# UNITED STATES PATENT AND TRADEMARK OFFICE

# Office Action Summary

09/319,842

WESTERMANN ET AL.

**FIG.1**

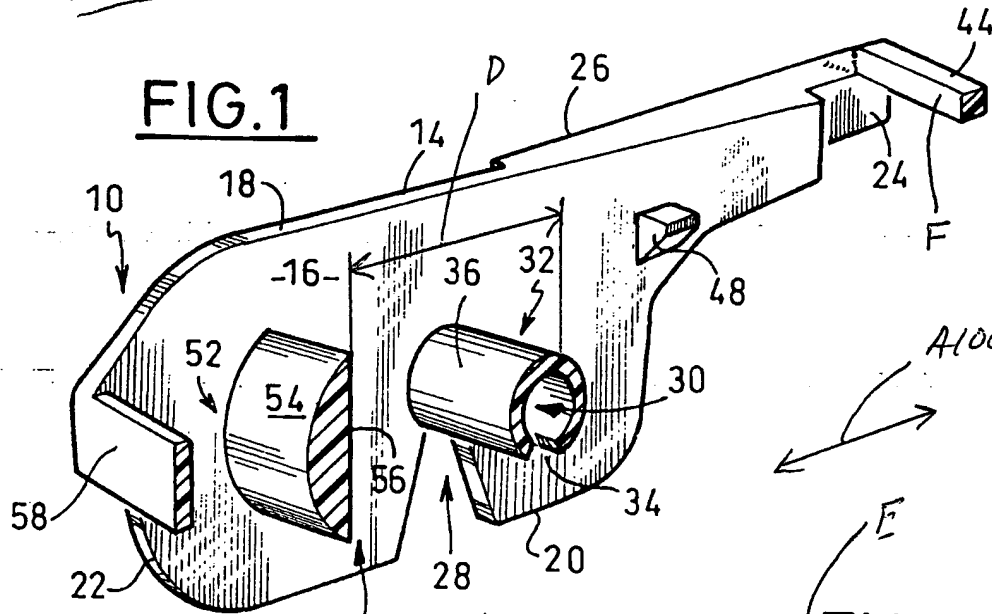
Regarding claim 1, the European patent '373 discloses in Figure 1 a bearing element **10** comprising a hub **32**, two side walls **14, 16**, contact faces **36, 56**, detent means **48** for holding the bearing element **10**, and lateral struts **44, 54**. The hub **32** is open over part of a circumference. The hub **32** connects the two side walls **14, 16**. The lateral struts **44, 54** extend in a longitudinal direction **A100** on both sides **A101** of the hub. The side walls **14, 16** have a smaller clearance **A1** and a larger clearance **A2**. Applicant is reminded that a recitation with respect to the manner in which a claimed apparatus is intended to be employed does not differentiate the claimed apparatus from a prior art apparatus satisfying the claimed structural limitations. *Ex parte Masham*, 2 USPQ2d 1647 (1987).

Regarding claim 2, the European patent discloses one of the clearances **A1, A2** of the sidewalls **14, 16** is reduced on one end **E** by beads **24**.

Regarding claim 3, an outer contour of the hub **32** has a contact face **36**. A first lateral strut **54** of the lateral struts **44, 54** is disposed at a distance **D** from the hub **32**.

Regarding claim 4, a first lateral strut **54** has a contact face **56**. Figure 1 shows a second lateral strut **44** of the lateral struts **44, 54** is disposed at a distance from the first lateral strut **54**.

Regarding claim 5, the second lateral strut **44** has a flattened contact face **F** that is oriented towards the hub **32** (Fig. 1).

Regarding claim 6, the European patent '373 discloses an additional lateral strut **58** disposed at ends **E** of the side walls **12, 14**.

regarding claim 7, the prior art of record does not disclose or suggest a bearing element including at least one detent projection of detent means for holding the bearing element, disposed on the side walls starting from the additional lateral strut; the European patent 655,373 teaches a projection of the detent means disposed on the side walls starting from the second lateral strut **44** instead; and,
